To: Mr. Kevin Mahoney	Date: August 11, 2014	Gale Job No. 828170 P03
Minuteman Regional High School 758 Marret Road Lexington, MA 02421	Re: Boiler Roof Replacement and Skylight Repairs Minuteman Regional Vocational Technical High School Lexington, MA	
<b>RE: Stair Materials</b>

To: Mr. Kevin Mahoney	Date: August 15, 2014	Gale Job No. 828170 P03
Minuteman Regional High School 758 Marret Road Lexington, MA 02421	Re: Boiler Roof Replacement and Skylight Repairs Minuteman Regional Vocational Technical High School Lexington, MA	
<b>RE: Planter Curb Materials</b>

To: Mr. Kevin Mahoney	Date: August 18, 2014	Gale Job No. 828170 P03
Minuteman Regional High School 758 Marret Road Lexington, MA 02421	Re: Boiler Roof Replacement and Skylight Repairs Minuteman Regional Vocational Technical High School Lexington, MA	
<b>RE: Displaced Masonry Wall</b>

To: Mr. Kevin Mahoney	Date: August 22, 2014	Gale Job No. 828170 P03
Minuteman Regional High School 758 Marret Road Lexington, MA 02421	Re: Boiler Roof Replacement and Skylight Repairs Minuteman Regional Vocational Technical High School Lexington, MA	
<b>RE: Wall Test Cut Findings</b>

Image C – Gale’s Design Drawing which incorporates excerpts of the original design drawings.

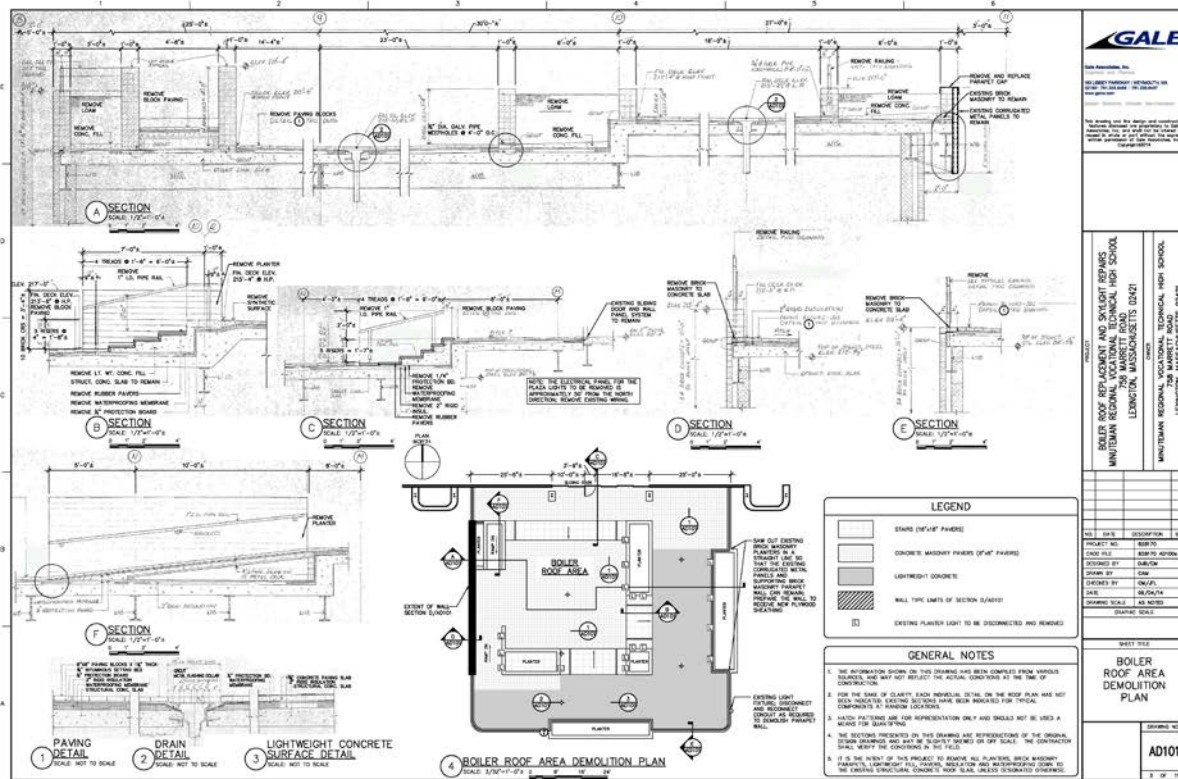
- All parties discussed the concrete material, and that the original detail drawings which were used as the basis of Gale's design indicated that the stair material was light weight concrete fill; refer to Image C which is Gale's Sheet AD101, which includes scans of the original design drawing presented as Image D.

- Gale’s drawing was modified to include the original design details, but incorporated the overburden substrates that were found on the existing roof system; refer to Image F.
- As the existing waterproofing and insulation system extended below the structural concrete stair system, these stairs needed to be removed, or trapped moisture would be present within the new roof system, which would result in moisture drive/condensation which would affect the bonding adhesives used for the roof components.
- Gale discussed the conditions with Minuteman via telephone, and discussed that the structural concrete material needed to be removed to prevent potential future delamination of the roof system.

Image C – excerpt of the original building design drawings which show the stair railings being set in “Lt. Wt. Conc. Fill”.

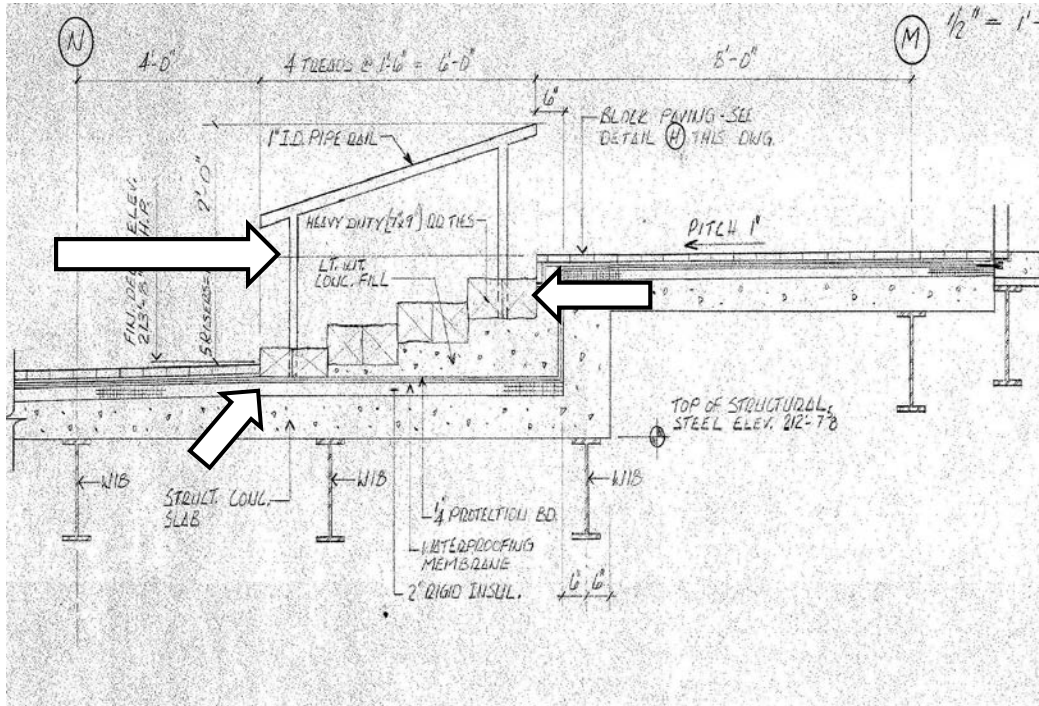
4. Capeway's demolition crew indicated that the hole was a result of the stairway railings extending down, through the waterproofing system, and being secured to the structural concrete slab. This detail is different from that which was shown on the original building drawings, which indicates that the railing was set in light weight concrete fill, above the waterproofing system; refer to Image C for an excerpt of the original building drawing which was used as a basis for the design.

Image D – original design drawing used as a basis for design.

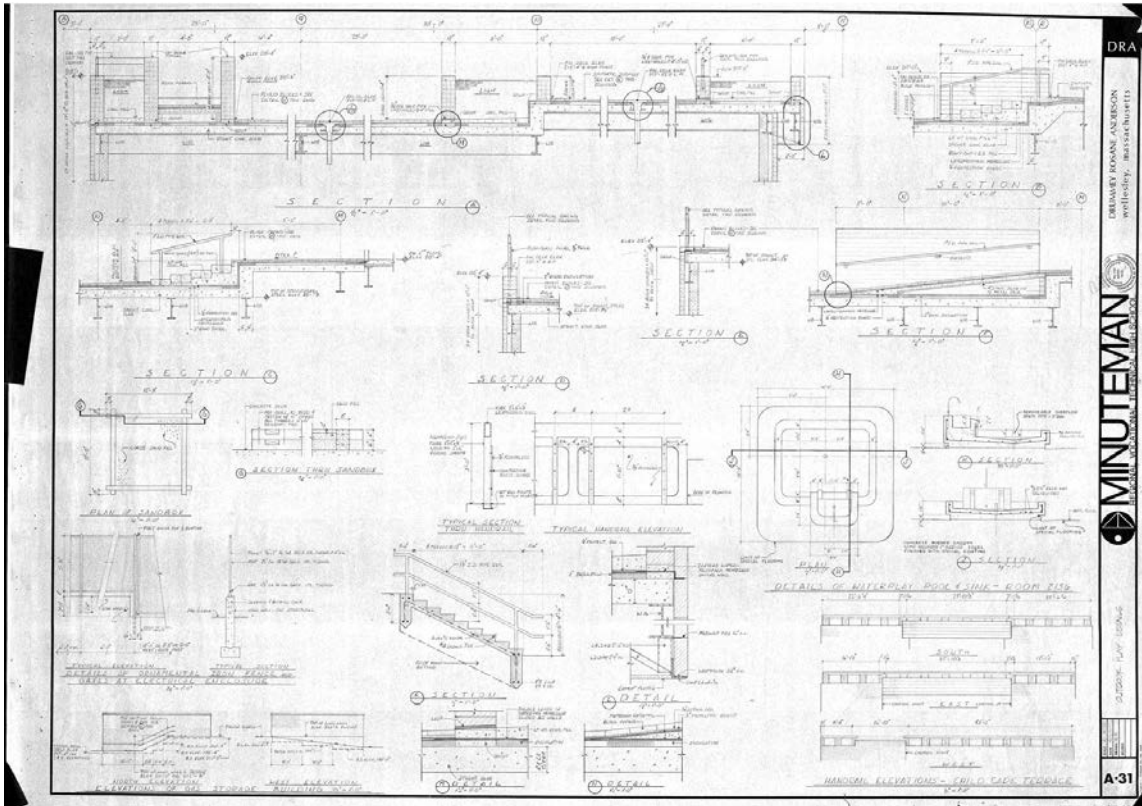
5. Gale was also requested to review the existing planter curbs at the site. During the design phase, Gale reviewed the available structural drawings which were provided to this office, none of which had reference to the above deck plaza components. As such, the architectural drawings were used as a basis of the design. Image D represents one of the original design drawings which were presented to Gale and shows the condition of the plaza deck components of this area.

Image E – original design drawing with industry standard brick masonry unit hatching within the planter walls.

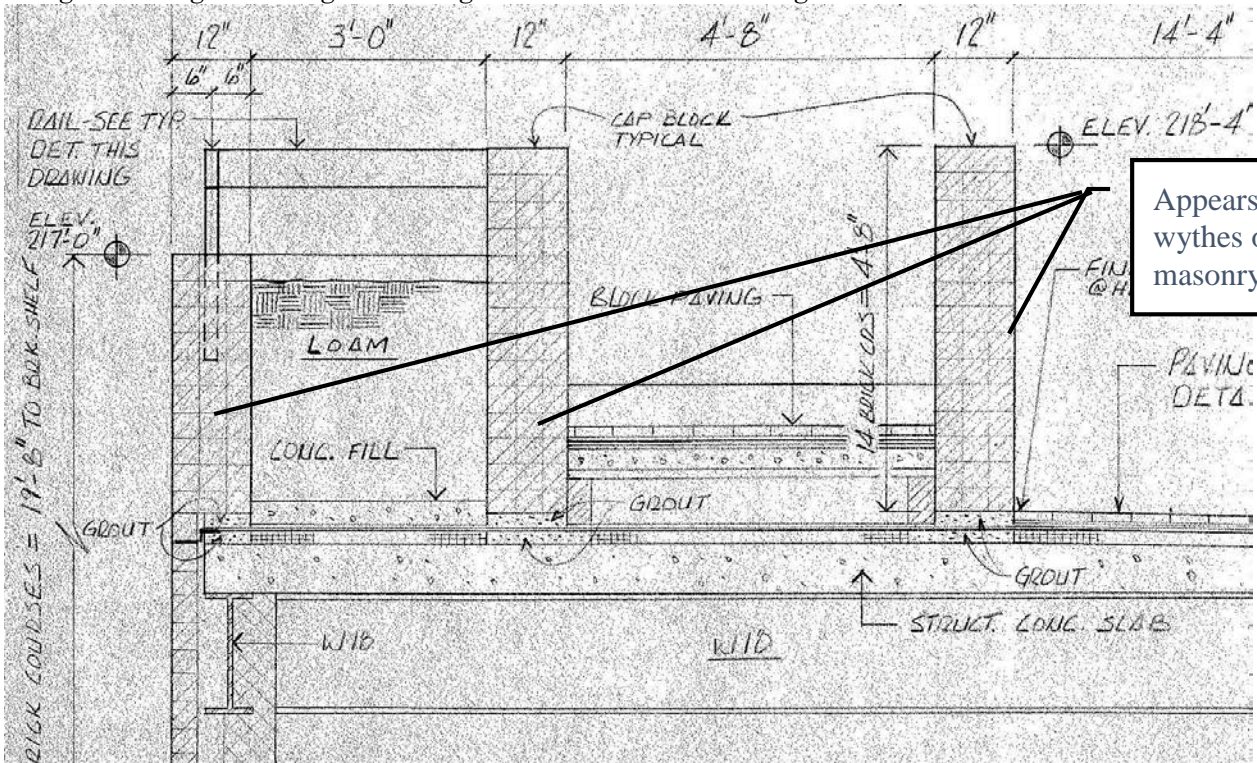
6. Both Images E and F represent close-ups of the original design sections presented in Image D. Each of the planter walls which extend up, above the plaza deck surface are depicted with the industry standard slanted hatch, which represents brick masonry units which are set atop a layer of grout on the structural concrete deck. The planter walls also represent that there are three wythes of masonry, which is consistent with the dimensions that were presented on the original design drawings, and were used as the basis for the design.

Image F – original design drawing with industry standard brick masonry unit hatching within the planter walls.

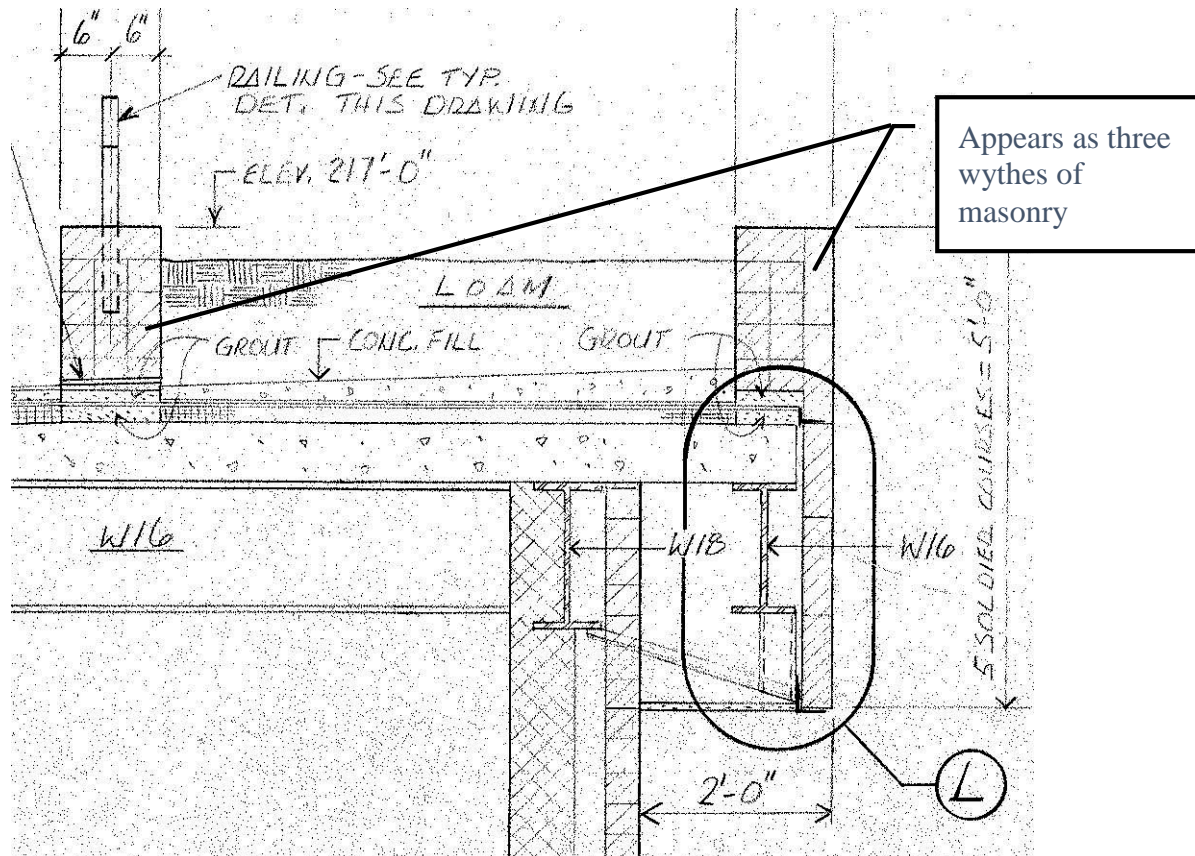
- Capeway indicated that upon removal of the top horizontal course of brick masonry, and the exterior wythe which was exposed to the typical walking areas of the plaza deck, a structural concrete curb was in place at each of the planter locations. Refer to photographs G and H.

Image B – West elevation. The net hatch references the area to be demolished to complete the roof replacement project; the arrow represents the initial area of concern.

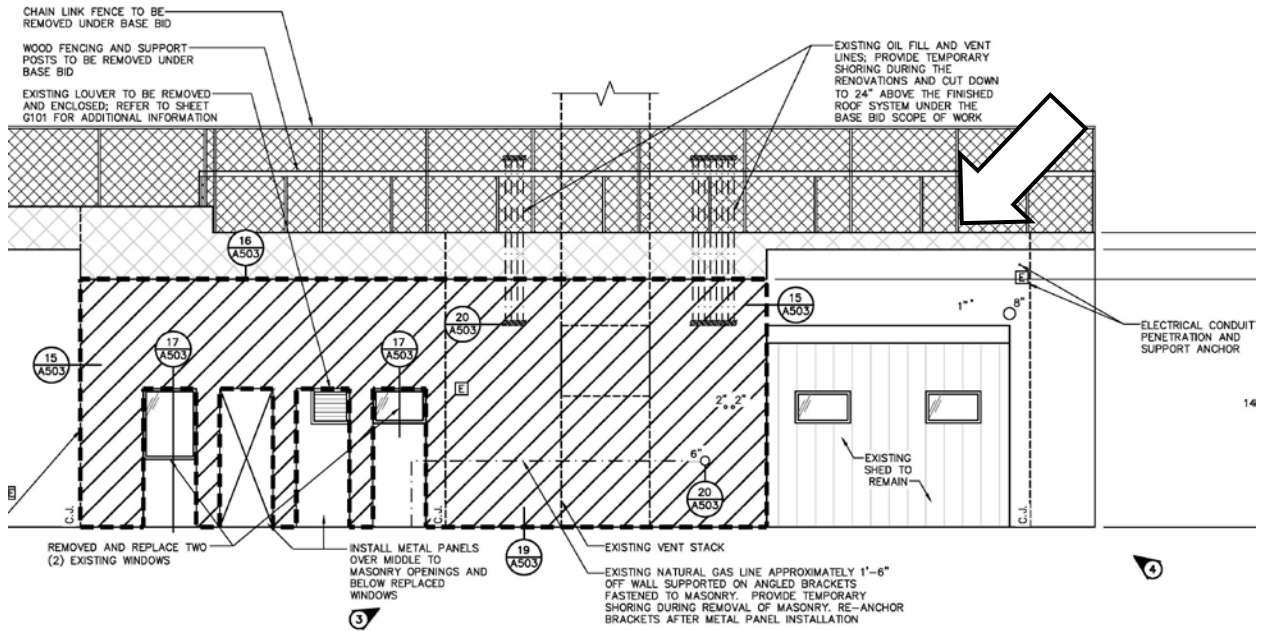
2. A portion of the brick masonry in this location is originally scheduled to be removed as part of the scope of work, and shown in Image B, which is an excerpt of Gale's original design drawing, Sheet A201. The masonry was to be taken down to just below the existing concrete roof deck, as to allow the new roof system to be installed, and the mortar below the removed areas were to be repointed to stabilize the wall.

5. As portions of this area were designated to be removed as part of the project, and the demolition work which was being performed adjacent to this area was vibrating the masonry wall, Gale directed Capeway's demolition crew to remove these components prior to their departure, as they were a potential fall hazard onto the structure and gas conduit lines below this area.

Image J – excerpts of the building’s original design drawings; a throughwall flashing within the wall system was not evident.

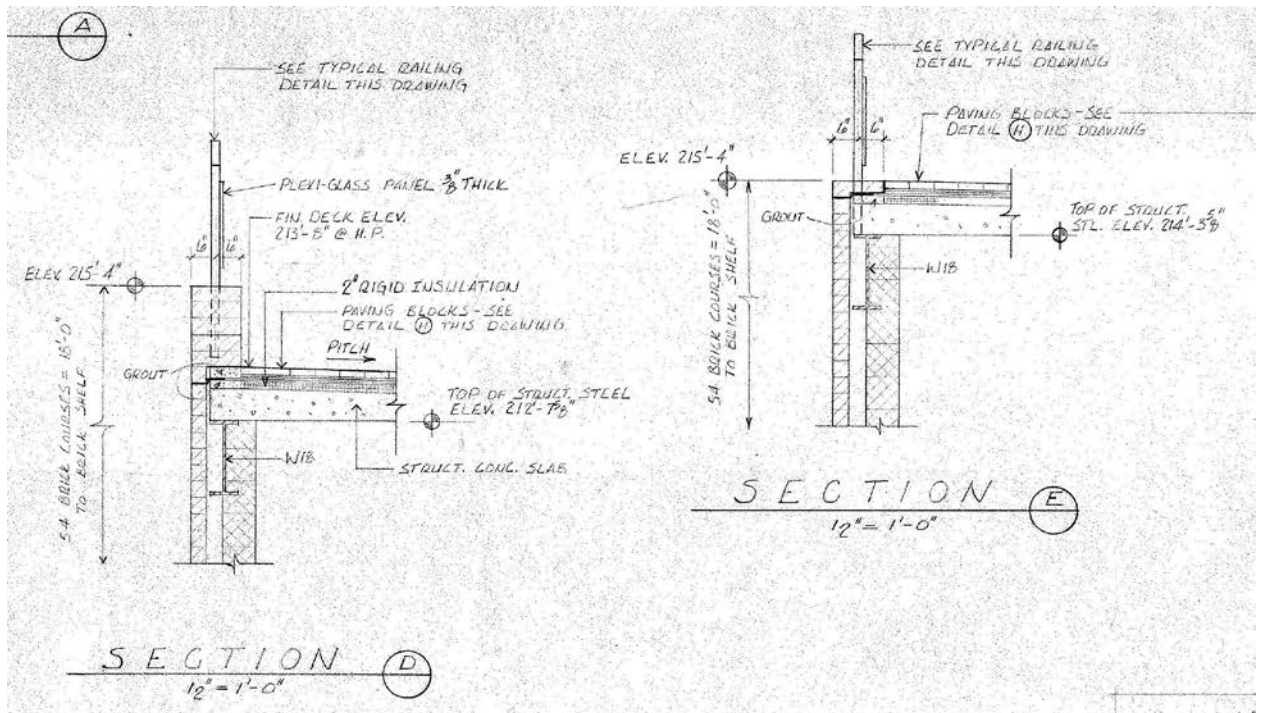
12. Gale reviewed the original building drawings, an excerpt is shown in Image J related to the perimeter walls. The exterior wall does show a “darker” line, which could be considered a throughwall flashing just above the roof deck location and under the brick masonry cap units, however, it is not called out or referenced in this, or other drawings provided to Gale for review. Note however, that a darker line from the backup wall, to the exterior masonry wythes had not been shown at the approximate sixth course down, presenting no indication that a throughwall flashing had been present. Please note that the masonry above this dark line was scheduled to be removed as part of this project to allow for the new roof details to be installed.

Photo J – West elevation; Note that the pintle in the foreground is not engaged in the eyehook, and that the pintle in the back ground is engaged, but both the eyehook and pintle are bent which can allow horizontal movement.

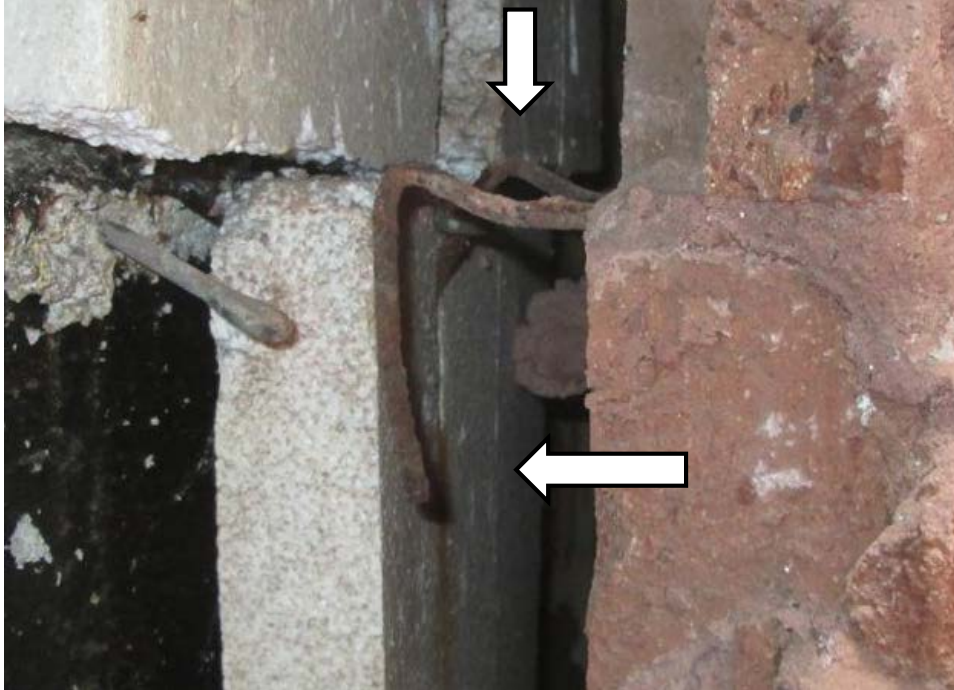
8. The test cuts revealed multiple different conditions related to the adjustable ties, which ranged from partially engaged pintles, missing pintles, and rusted eyehooks. Refer to photographs J, K, L, M and N.

15. During the construction meeting, all parties discussed potential repairs which should be considered to address the rising wall conditions below the roof edge. Minuteman/Gale have requested proposals from Capeway to perform the following:

- Install helical masonry anchors through the brick masonry into the backup wall; there is approximately 1,662 square feet of area to receive the anchors, which are to be spaced at 16" on center, horizontally and vertically.

Image A

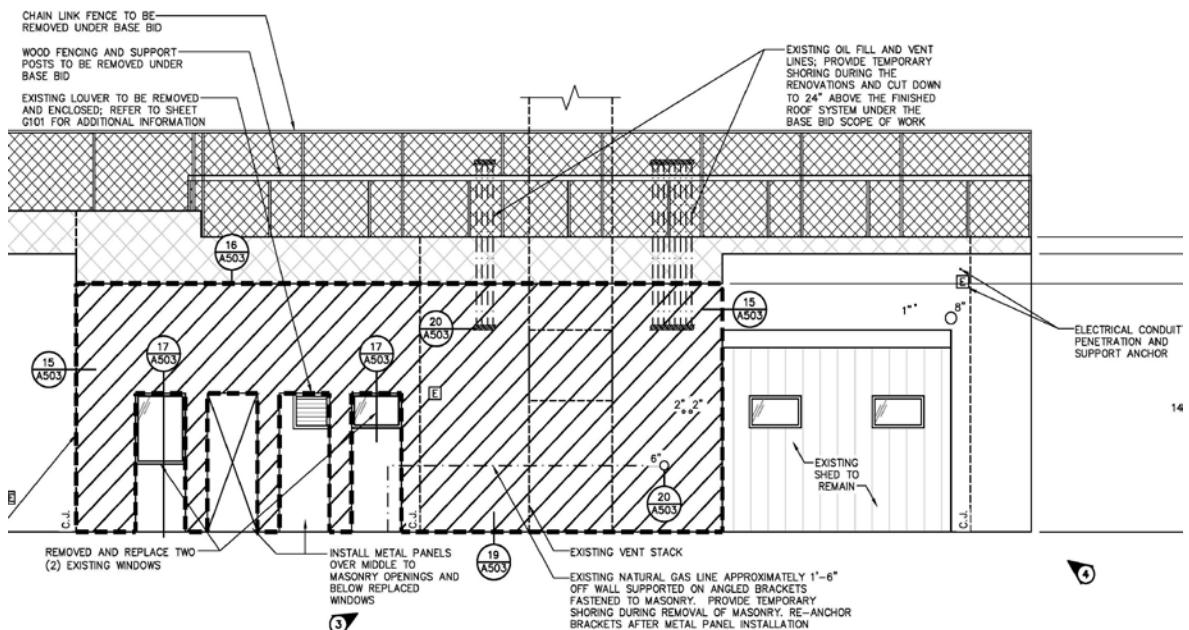
1. Earlier in the week, the Capeway demolition crew started the removal of the existing exterior wall as designated on the contract drawings; refer to image A for the approximate location. The intent of the removal operations was a result of the severe damage to the exterior brick masonry units, which appeared to be caused by water infiltration around the perimeter of the roof system above; refer to photographs B and C for a file photograph of the wall system prior to the removal operations.
